## **Q25-020 - Mill Courtland Community Centre Addition**

### **Addendum #3**

April 1<sup>st</sup>, 2025

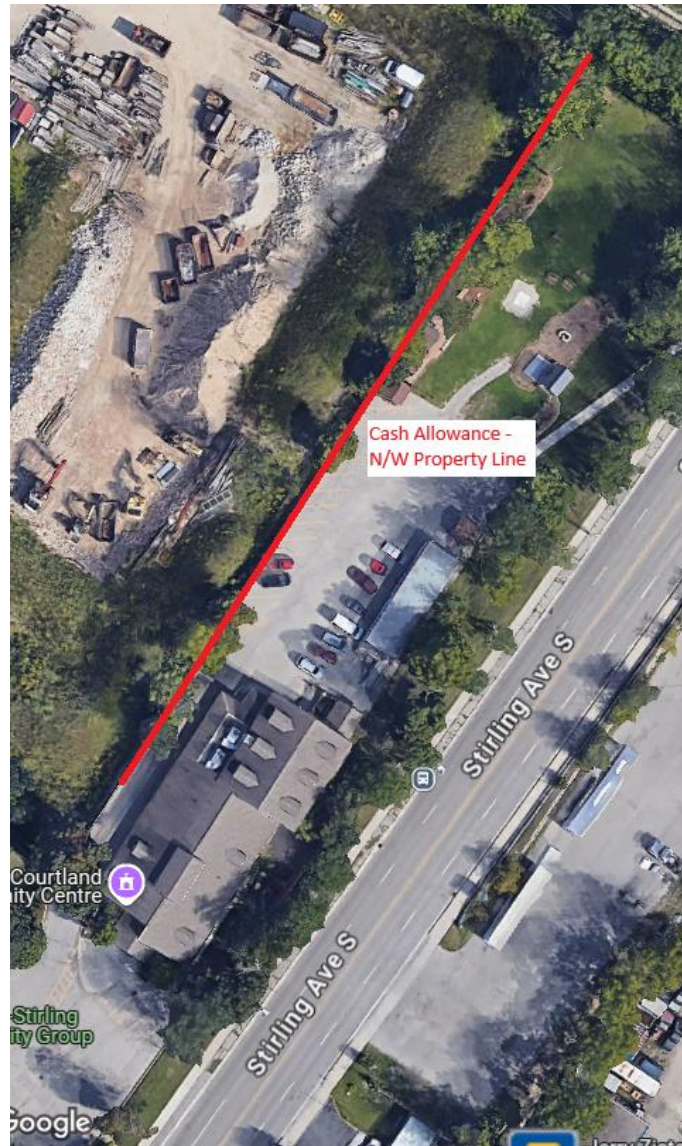
- **North West Property Line Low Impact Excavation cash allowance: \$40,000**
  - This cash allowance is to be used only along the northwest property line (see image below – red line), as the tree preservation plan does not identify affected trees along this area of work. For bidding purposes, the contractor should assume standard excavation and removal processes along this property line. This cash allowance does not apply to other areas where the Arborist Report or Tree Preservation Plan specifies requirements for low-impact / soft excavations.
